Version C Villa Door Stations V2.2.65_230703

Release Note (2023-07-25)

Firmware Basic Information	Firmware Version	V2.2.65_build230703
	Device Model	DS-KV8X13-WME1(C) DS-KV6113-WPE1(C), DS-KV6113-PE1(C), DS-KV6103-PE1(C) DS-KIS603-P(C), DS-KIS604-P(C), DS-KIS604-S(C)

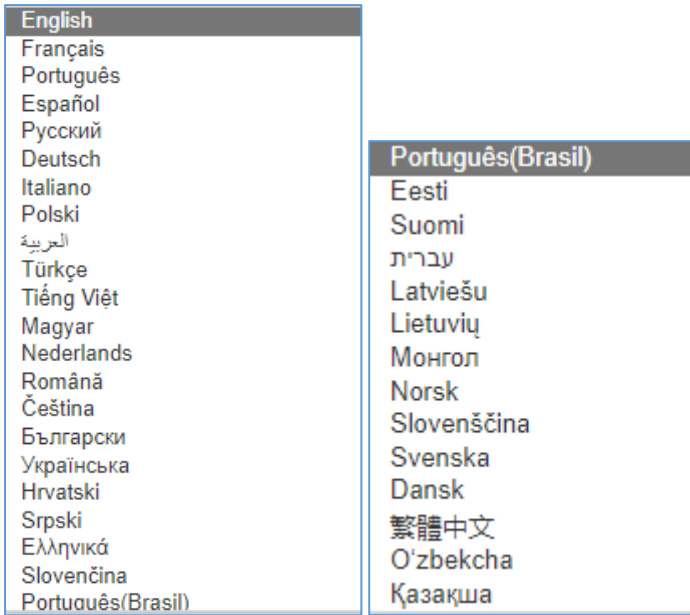
1. Add Account Security Settings function, you can reset the password with security question or your email address.

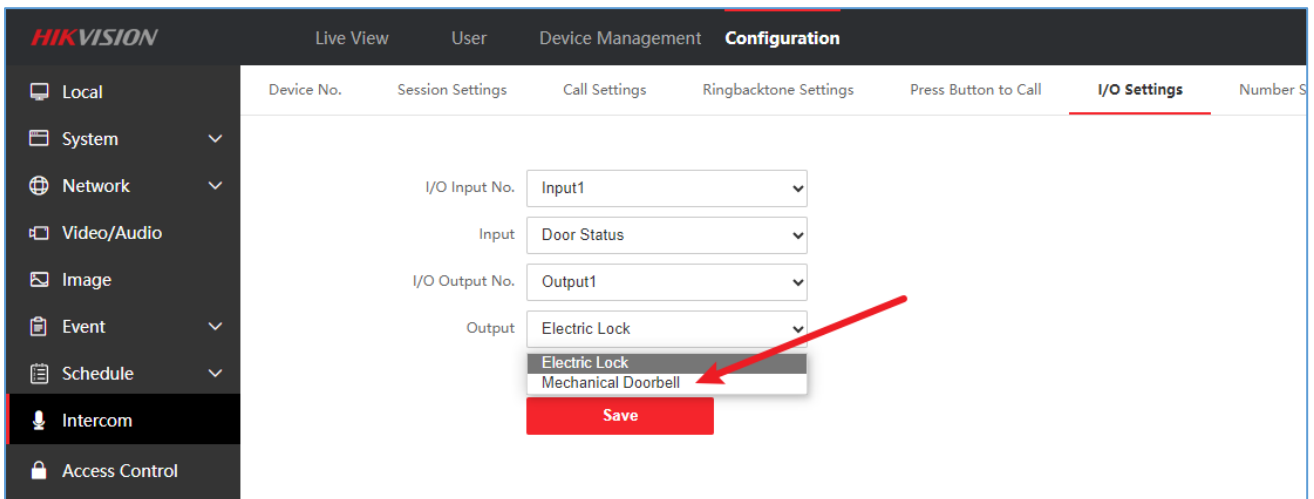
2. Add 13 new languages, now in total support 35 languages. Only two voices "door is open" and "please leave a message" are retained, and the rest of the prompt tones are replaced by Didi, busy tones, etc
